ORIGINATION FORM

Proposed Revisions to a Standard Plans Index
(Please provide all information — Incomplete forms will be returned)

Index Number: 425-025
Sheet Number (s): ALL
Index Title: Curb Inlet Top Type 10

LAST REVISION 11/01/17	DESCRIPTION:	FDOT FY 2019-20 STANDARD PLANS	CURB INLET TOP TYPE 10	INDEX 425-025	SHEET 1 of 1
---------------------------	--------------	--------------------------------------	------------------------	------------------	-----------------

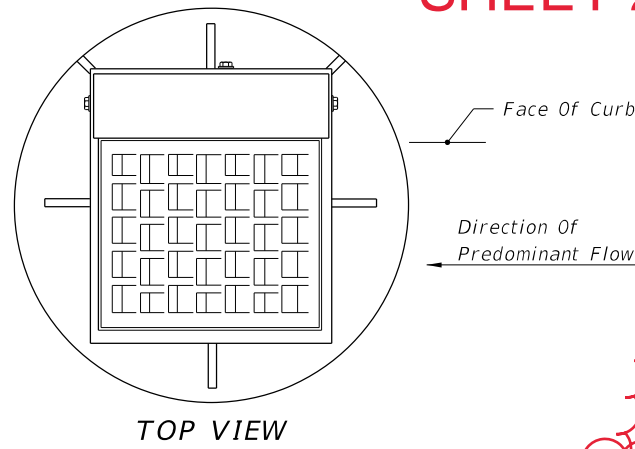
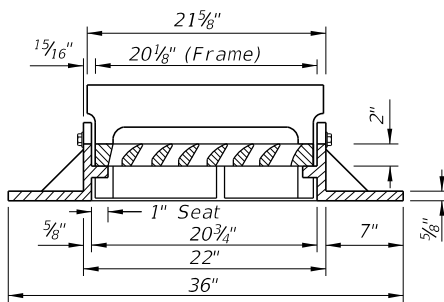
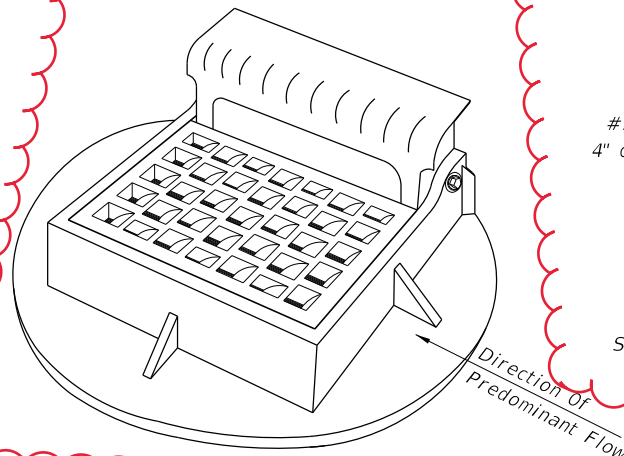
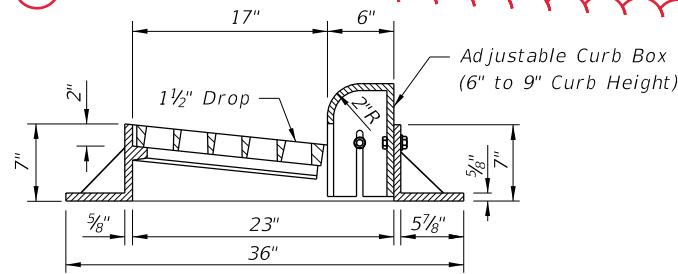
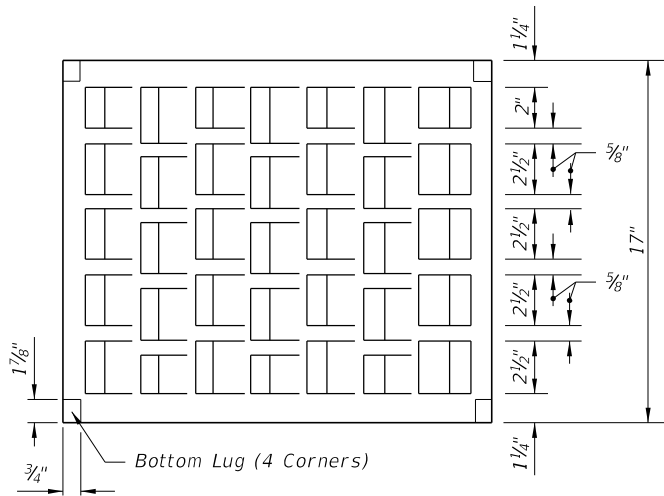
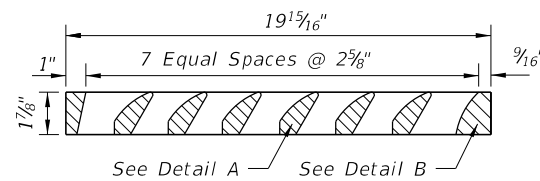
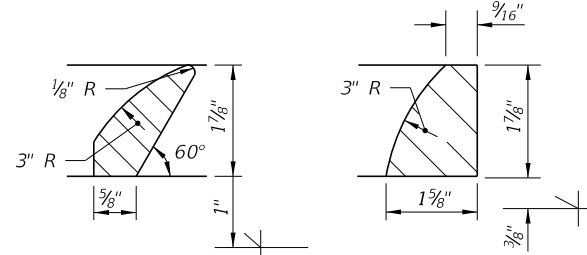
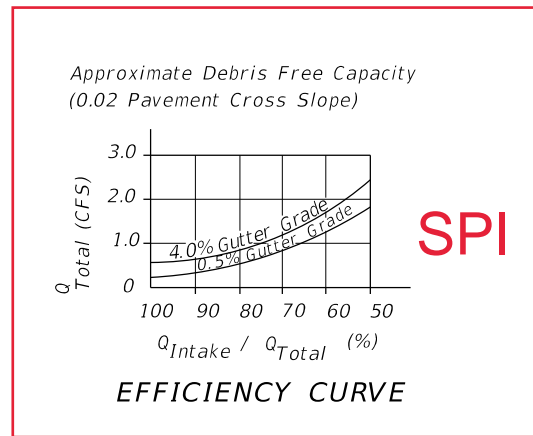
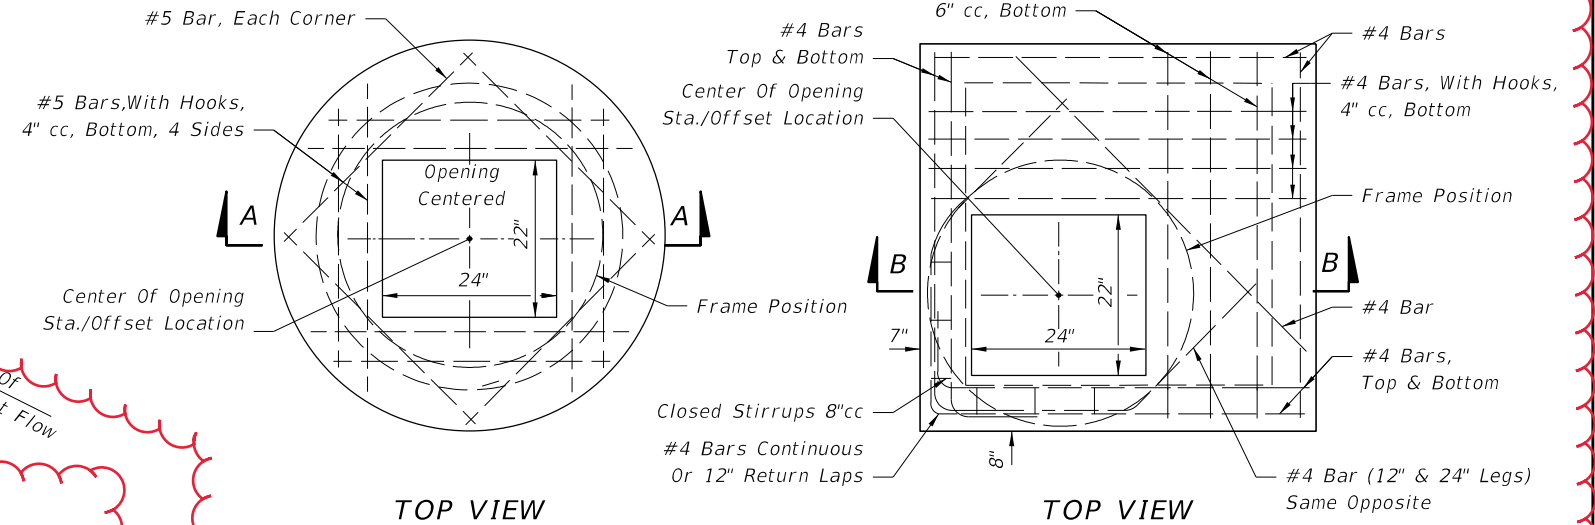
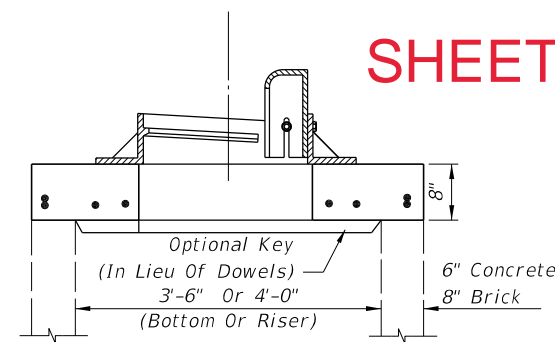
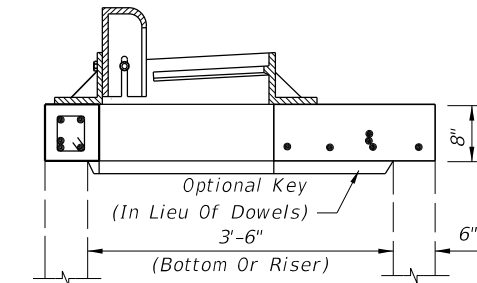
NOTES UPDATED

Reorganized Index, Added additional Sheets.
Sheet 1: General Notes
Sheet 2: Frame and Grate Details
Sheet 3: Top Slab Details

Reorganized Details and Sheets to declutter Index. Moved information from detail callouts to Notes in order to decrease clutter of the drawing. Moved design information to SPI.
